Access Compliance Report

Public Rights-of-Way

Intersection ID: 10035557	Main Street: REA_RD	Cross Street: N/A	Location: SE
ADA ID: 95881901E26B	Ramp Type: PerpDiag	Initial Pass/Fail: Fail	Overall Compliance: No
Severity Score: 22.5			
Codes/Mitigation Info/Possible Solution		Field Measurements/Component Compliance

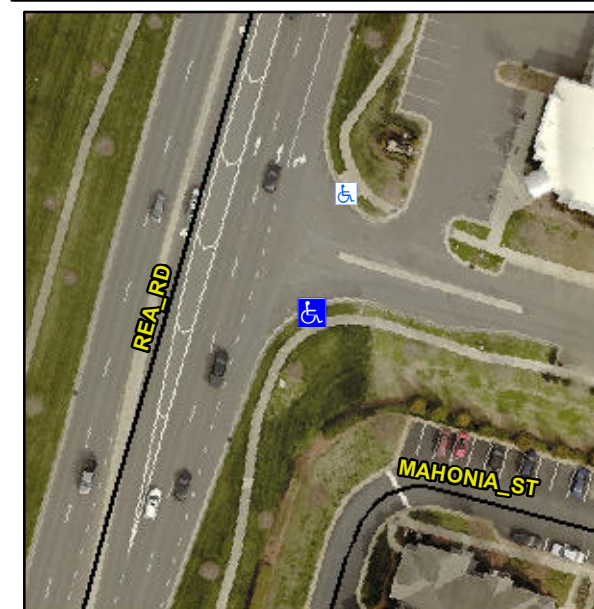
Not Found, R304.5.1, R304.2.2, R304.5.3

Compliance	Description	Data	Compliance	Description	Data
N/A	Ramp Length (in)	75.0	No	Ramp Slope (%)	11.7
No	Ramp Width (in)	44.0	No	Ramp XSlope (%)	3.3
N/A	Flare Type LT	N/A	N/A	Flare Type RT	N/A
N/A	Flare Slope LT (%)	N/A	N/A	Flare Slope RT (%)	N/A
N/A	Flare Traversable LT?	N/A	N/A	Flare Traversable RT?	N/A
N/A	Landing Length (in)	N/A	N/A	DWS Provided?	N/A
N/A	Landing Width (in)	N/A	N/A	DWS Contrast?	N/A
N/A	Landing Slope (%)	N/A	N/A	DWS Length (in)	N/A
N/A	Landing X Slope (%)	N/A	N/A	DWS Full Width?	N/A
N/A	Landing Curb? (Y/N)	N/A	N/A	DWS Offset (in)	N/A
N/A	Shared Landing?	N/A			
N/A	Gutter Ponding?	N/A	N/A	Gutter Slope (%)	N/A
N/A	Gutter Lip Ht (in)	N/A	N/A	Gutter X Slope (%)	N/A
N/A	Painted X Walk1?	No	N/A	Painted X Walk2?	No
	X Walk 1 Direction	To NE		X Walk 2 Direction	To NW
N/A	X Walk 1 Width (in)	N/A	N/A	X Walk 2 Width (in)	N/A
	X Walk 1 Slope (%)	0.9		X Walk 2 Slope (%)	3.4
	X Walk 1 X Slope (%)	2.3		X Walk 2 X Slope (%)	0.7

Remove & Replace Curb Ramp With Two New Directional Ramps or Equivalent.
